Work Order ID 84146

Item Name: Lug Assembly

DRAWING NO. D3394	TITLE LUG	REV. B	DART AEROSPACE LTD ENGINEERING ORDER		D.E.O. NO. D3394-B-1	SHEET NO. SHEET 1 OF 1	SCALE NTS
DRAWN AJS	CHECKED	MFG. APPR.	APPROVED		DE APPR.		
DATE 09.11.04	DATE 09.11.04	DATE 09.11.04	DATE 09/11/04		DATE 09/11/04

DRAWING NO. D3394	TITLE LUG	REV. B	DART AEROSPACE USA, INC ENGINEERING ORDER		D.E.O. NO. D3394-B-2	SHEET NO. SHEET 1 OF 1	SCALE NTS
DRAWN <i>qp</i>	CHECKED <i>Sc</i>	MFG. APPR. <i>M</i>	APPROVED <i>MP</i>		DE APPR. <i>MP</i>		
DATE 11.05.02	DATE 11.05.09	DATE 11.05.09	DATE 11.05.09		DATE 11.05.09

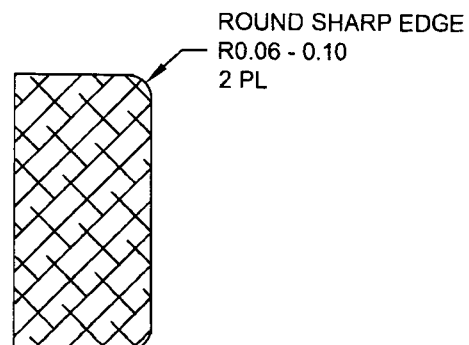
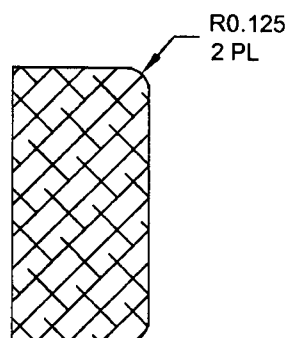
SHEET 4 ZONE A,1 MODIFY SECTION A-A AS SHOWN:

REASON: DRAFTING ERROR

IS:

WAS:

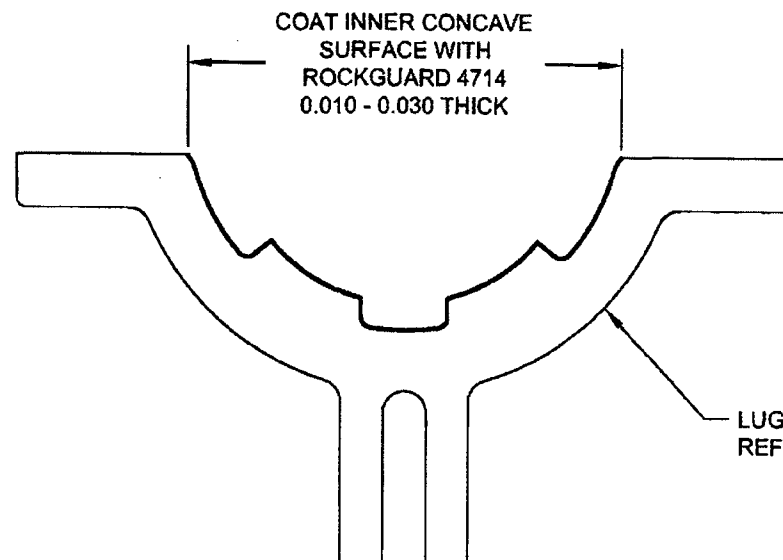
ADD D3394-xRG OPTION

D3394-xRG MOUNTING LUGS ARE IDENTICAL TO D3394-x MOUNTING LUGS, HOWEVER AFTER FINISH, COAT INNER CONCAVE SURFACE WITH "PLUS ONE ROCKGUARD 4714" AS SHOWN BELOW.

D3394-1RG LUG (SHOWN)
D3394-3RG/-5RG LUGS (SIMILAR)
D3394-041RG/-043RG/-045RG LUG ASSEMBLIES (SIMILAR)
